MULTIPLE FUNCTION SWITCH UPDATE ROTAX 125 MAX evo engine series

Multiple Function Switch

2) Removal of grease from the connector

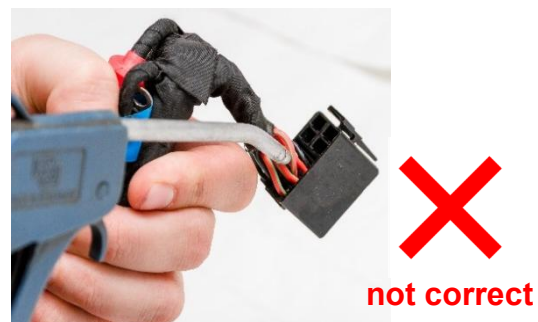
After careful investigation, the reason for switch failures (engine start problems, possible engine misfire) has been addressed as follows:

Grease isolating the contacts, inside the switch, causing the failure.

1. Disconnect the switch from the wiring harness.
2. Wrap a cloth around the wiring harness to prevent the tape from coming off.
3. Use compressed air to blow (approx. 10 seconds) the grease out of the connector towards the wiring harness. Make sure the grease can escape.

4. Spray (approx. 5 seconds) contact cleaner into the connector and on the contacts inside. If no contact cleaner is available, also brake cleaner can be used.
5. **Repeat the steps 3 and 4, 2-3 times until the connector is 100% free of grease!**

NOTE: Replacing the switch only, without removing the grease will lead to a failure again!

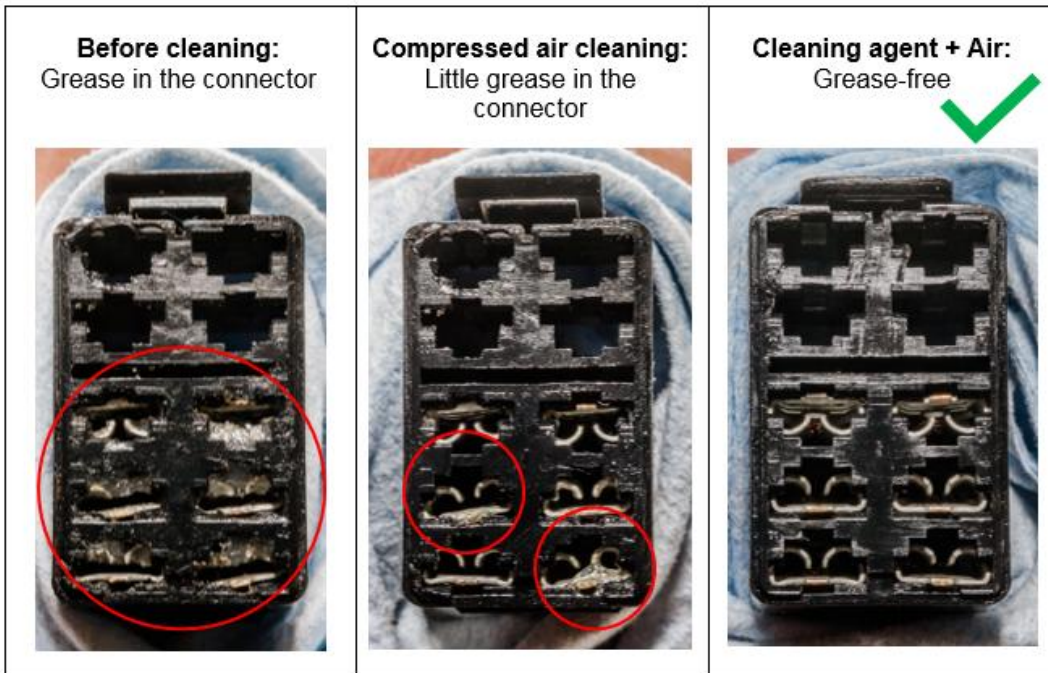
The removal of grease is only valid for the connector of the switch, not for any other connector of the wiring harness!

Switch, sealing of the parting line

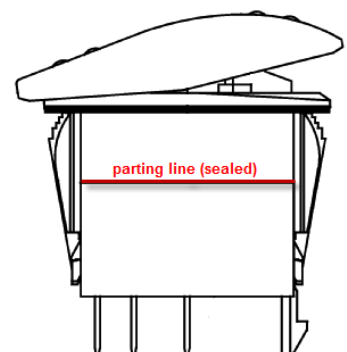
NOTE: The switch is sealed on the parting line to prevent water intrusion.

For this reason, the switch must not be opened!

By opening the switch this will break the sealing which can cause failure and warranty becomes void.
